# PRELIMINARY & FINAL DRAINAGE PLAN

## CARRIAGE MEADOWS SOUTH AT LORSON RANCH FILING NO. 2

PUDSP-19-005

## Summary of Comments on Microsoft Word - 100.046- PDR&FDR

### Detention Basin Outlet Structure Design

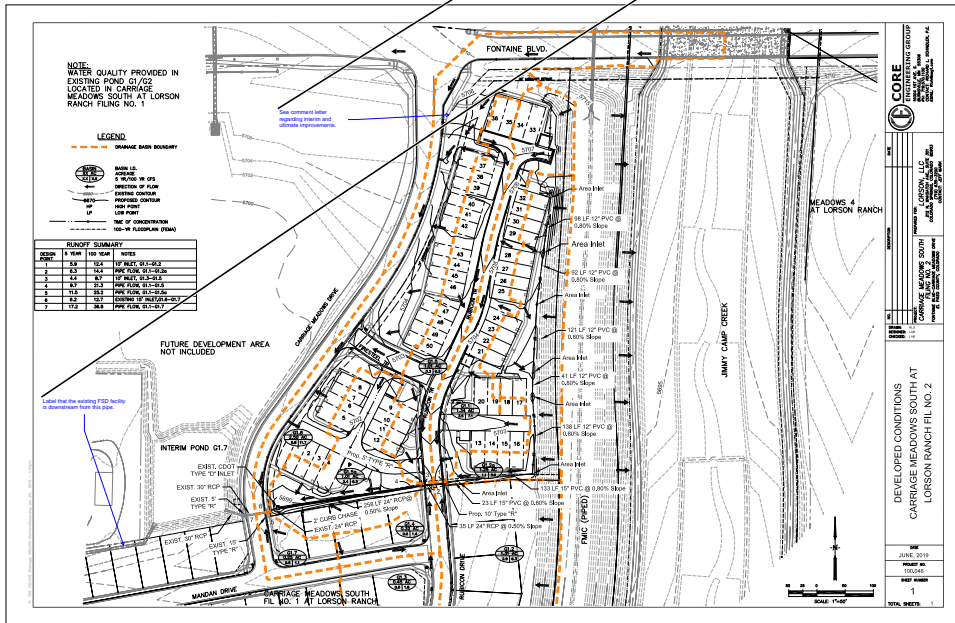
Can this be adjusted? Is the outlet structure designed to be updated with each additional development?

Can this be adjusted? Is the outlet structure designed to be updated with each additional development?

Author: RSchindler Subject: Sticky Note Date: 10/14/2019 8:52:11 AM  
 This would be hard to adjust since the outlet structure designed/built for full buildout.

COVER SHEET  
STREET/STORM SEWER  
AND UTILITY PLANS

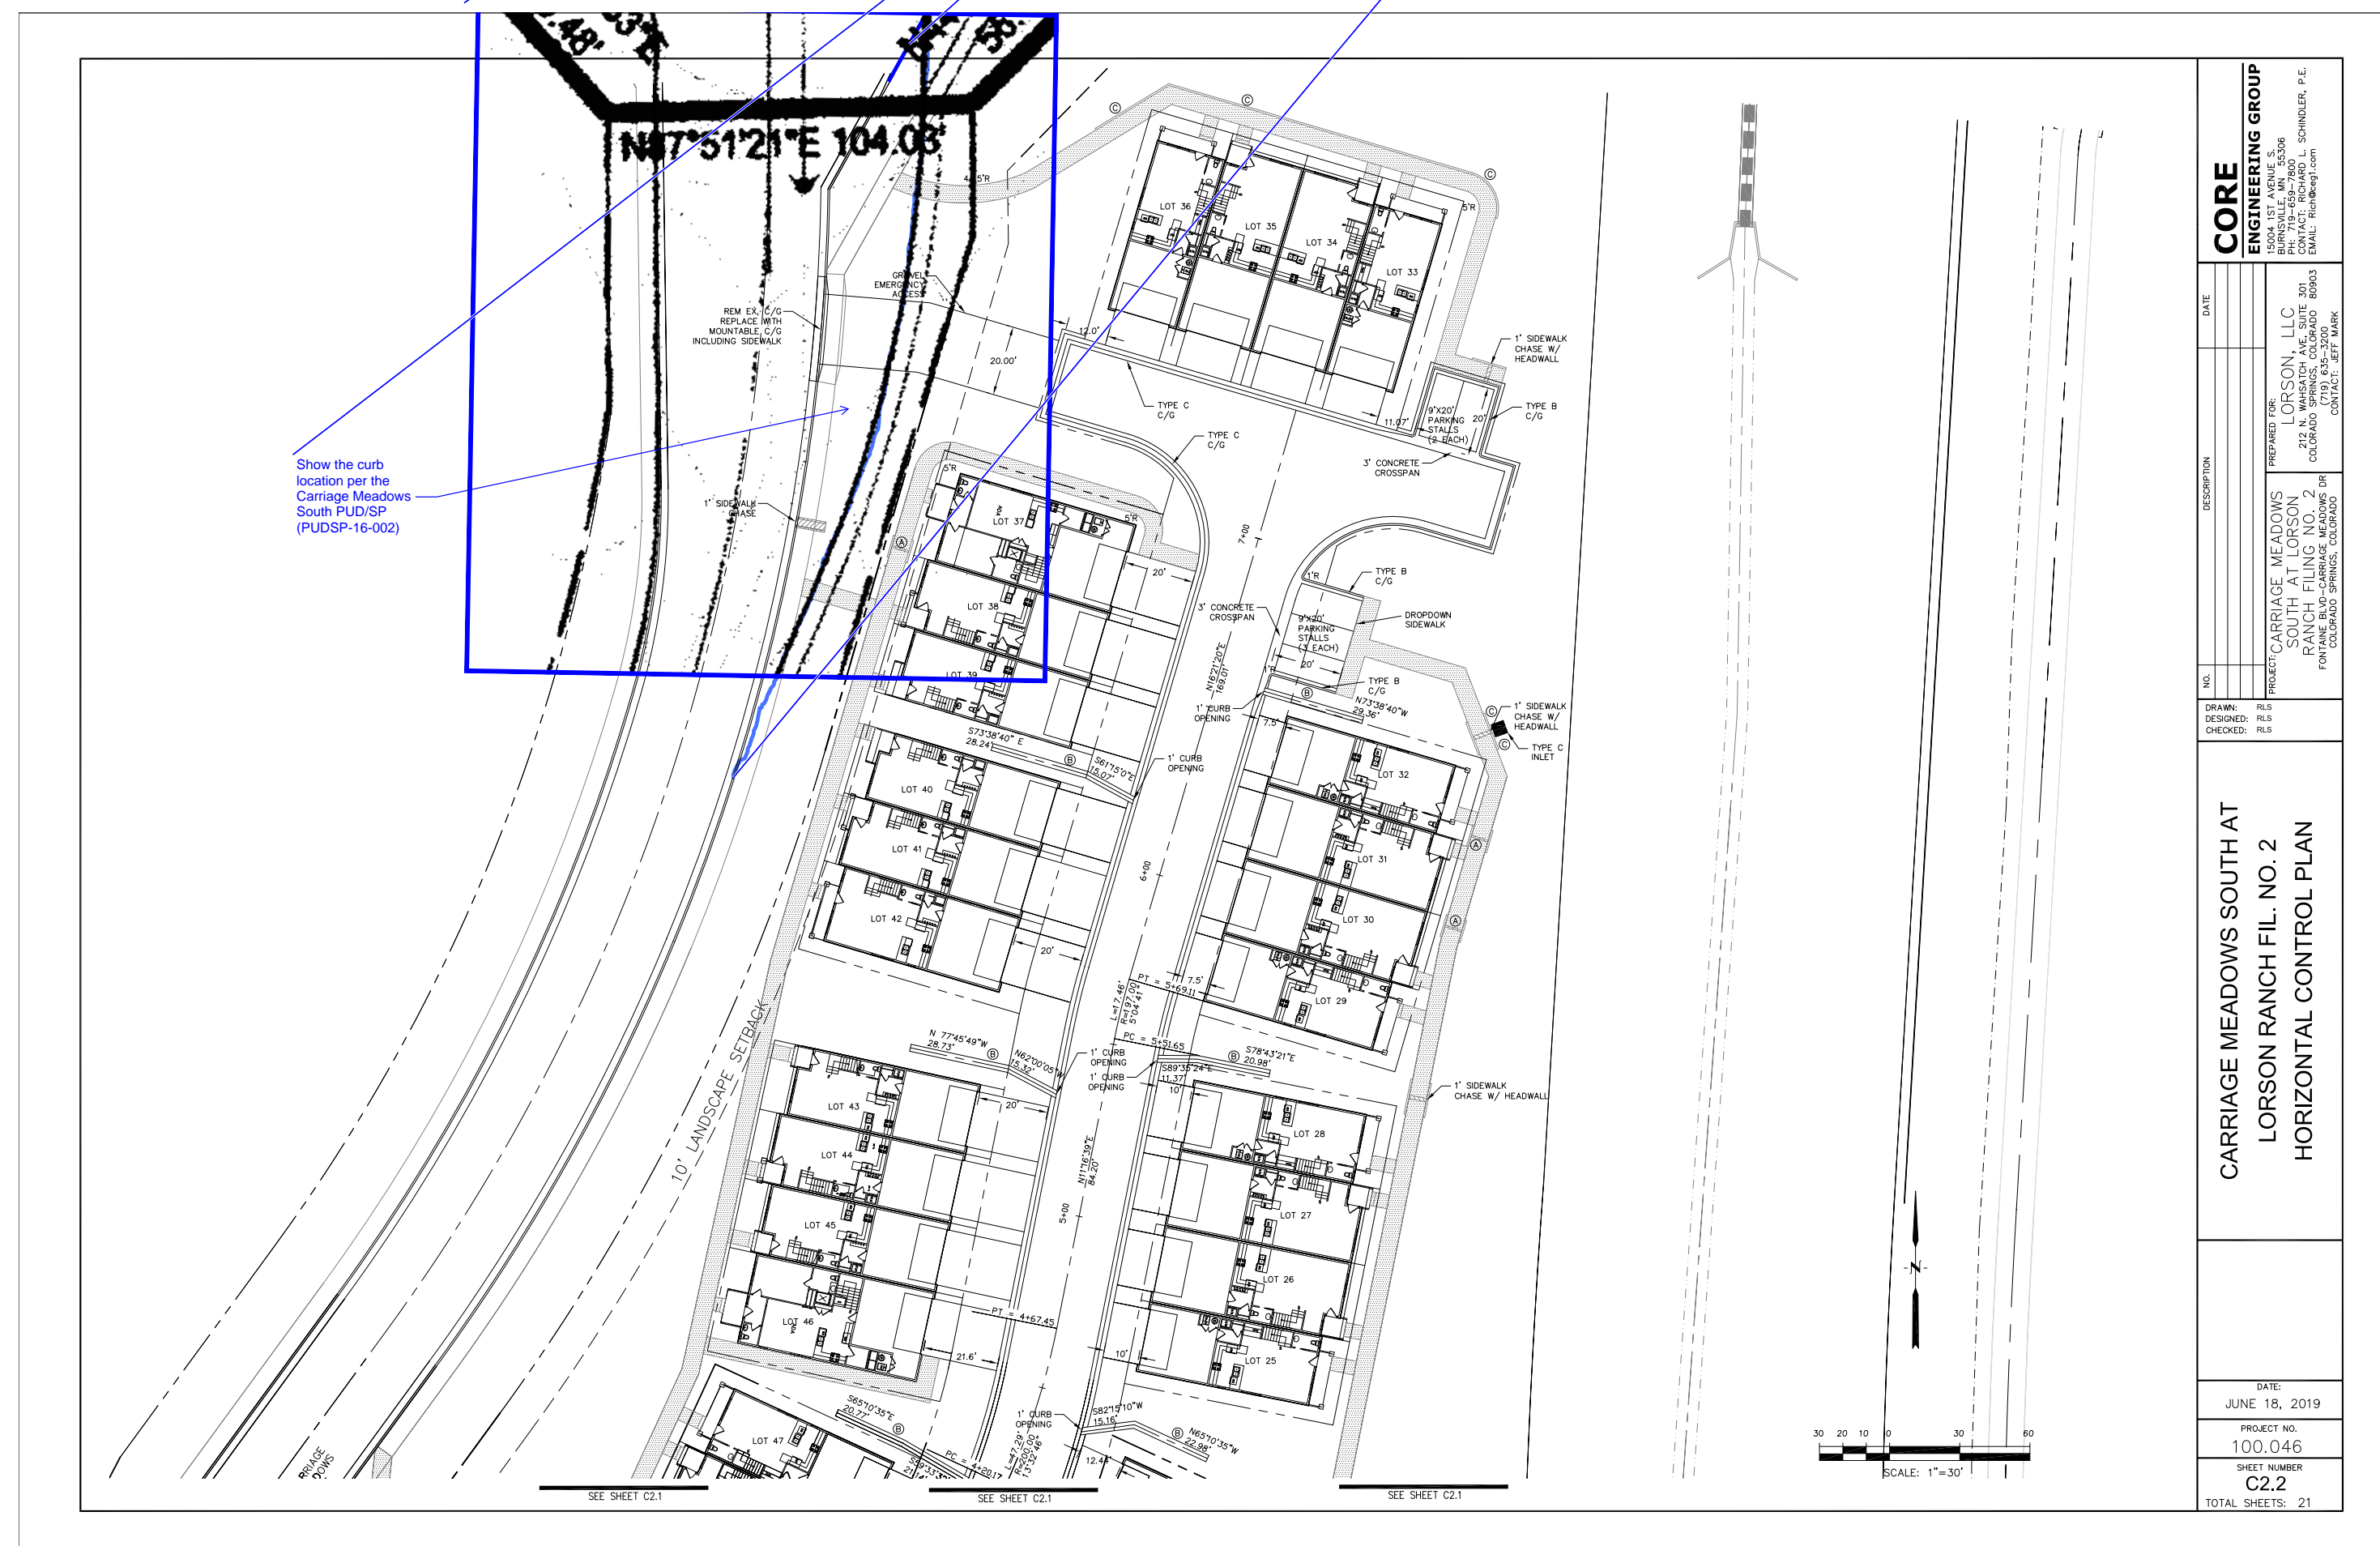
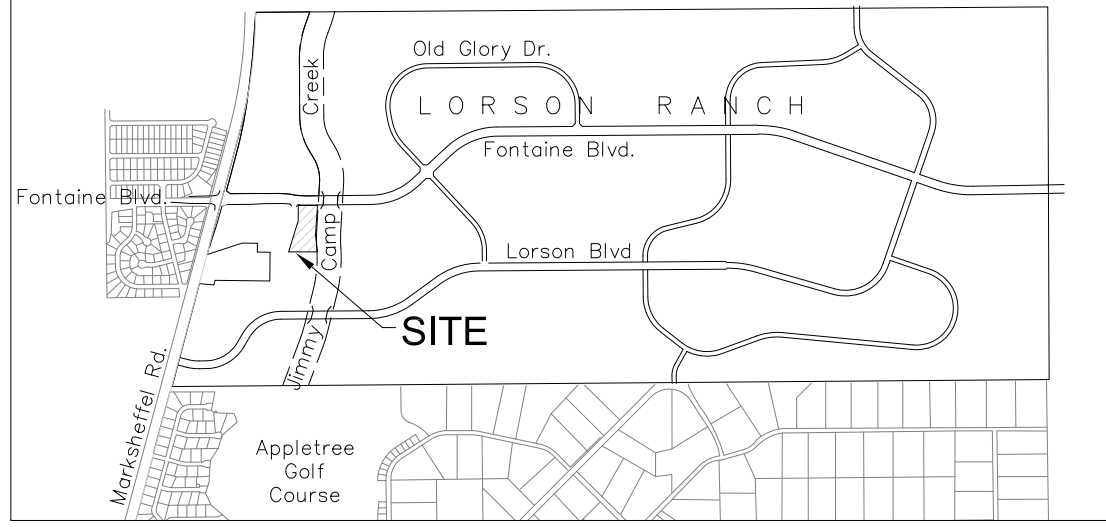
See comment letter regarding interim and ultimate improvements.

Label that the existing FSD facility is downstream from this pipe.

Author: RSchindler Subject: Sticky Note Date: 10/14/2019 8:54:41 AM  
rt turn lane improvements shown

Author: RSchindler Subject: Sticky Note Date: 10/14/2019 8:54:23 AM  
Label added
